Township of Bensalem, Bucks County, Pennsylvania Notice of Appeal

Grant a sideyard setback variance from Section 232-167(e)a to permit me to build a deck with a 0ft sideyard setback.

Project:	DECK/CONCRETE SLAB
Project Address:	882 Simons Ave Bensalem, PA 19020
Tax Parcel:	02-061-215
Property Owner:	Same as addressed
Permit Status:	Application Denied

NEW REAR DECK FOR THE HIGGINS RESIDENCE 882 SIMONS AVENUE BENSALEM, PA

SITE PLAN
1" = 20'

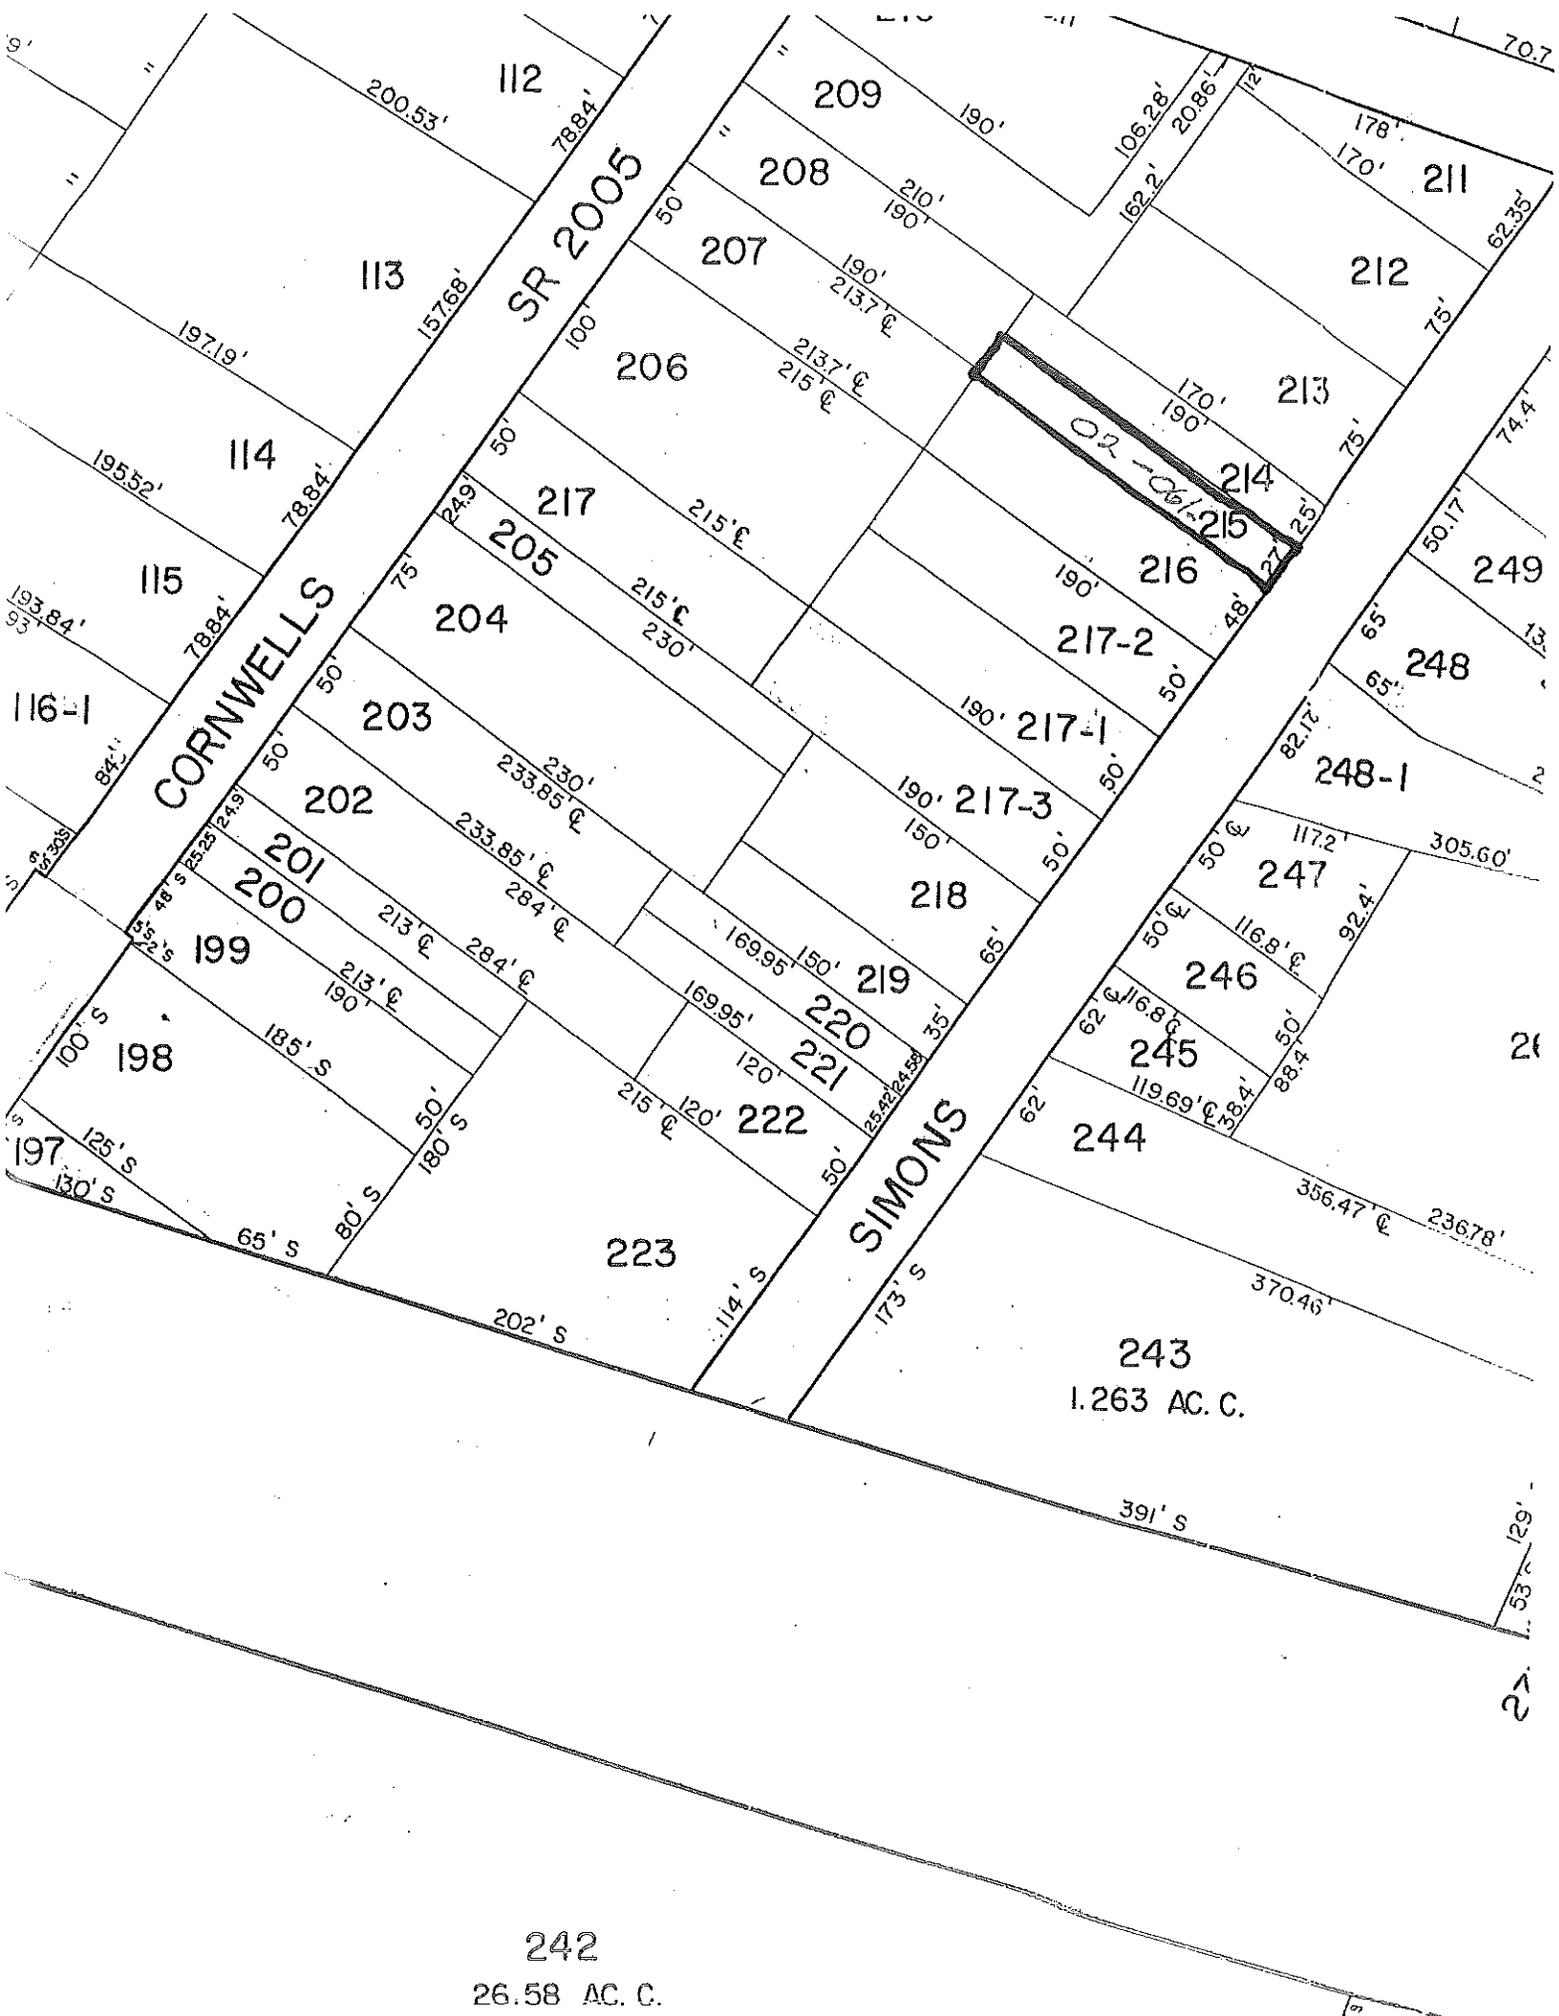
The 0 ft sideyard setbacks are less than the required 20 ft aggregate and 9 ft minimum.
[Section 232-167(e)a]

The 0 ft sideyard setbacks are less than the required 20 ft aggregate and 9 ft minimum.
(Section 232-167(e)a)
